## **Pre-Submittal Call**

**License Amendment Request for  
Change in DAEC Emergency Plan  
Emergency Planning Zone Boundary**

**July 13, 2016**

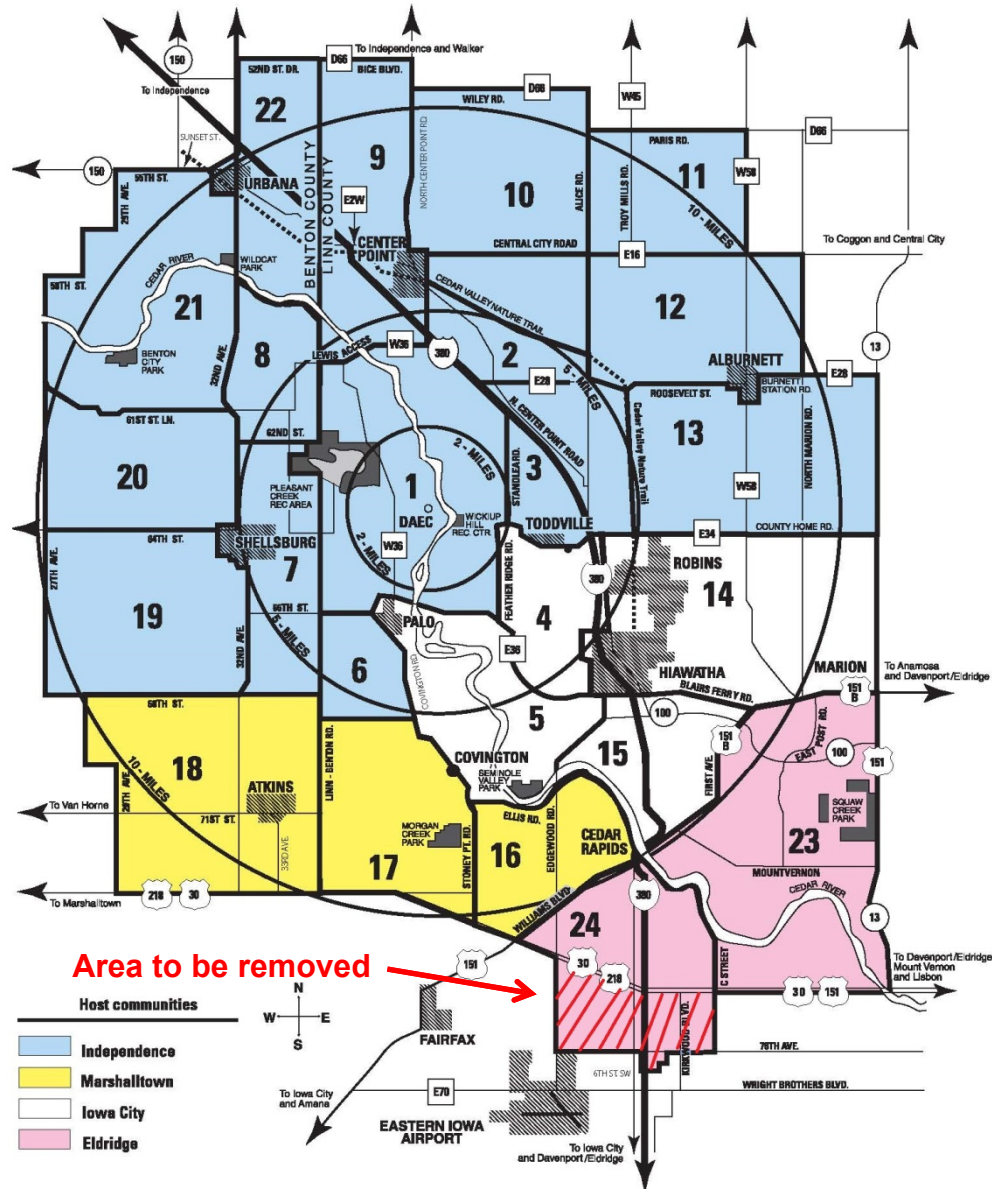
- Reflect the desire of Linn County to modify subarea 24 in the EPZ *(current & proposed EPZ Maps provided in final slides)*.
- Remove the area south of U.S. Highway 30 in subarea 24. This area is 12 to 15 miles from the plant, and entirely outside the 10-mile radius of the plant.
- Align the EPZ southern boundary with US Highway 30 and make a continuous boundary along the entire EPZ southern boundary. U.S. Highway 30 is a four-lane divided highway with controlled access *(photo provided in final slides)*.
- Aid in traffic control, messaging, and planning.

- **E-Plan Section I**, “Accident Assessment” proposed change to the EPZ Boundary Map, Figure I-1 (EPZ Boundary Map will be updated).
- **E-Plan Appendix 3**, “DAEC Evacuation Time Estimate Study,” Dec. 2013.
  - Preliminary ETE Study was completed and submitted with Linn County EMA’s June 2016 FEMA EPZ Boundary Modification request. Note that Iowa Homeland Security and Emergency Management provided support for the proposal to FEMA.
  - A full ETE Study will be completed in 2016 prior to LAR submission to the NRC.
- **EPIP 3.3**, “Dose Assessment and Protective Actions” Attachment 1 (Evacuation Time Estimates will be updated)
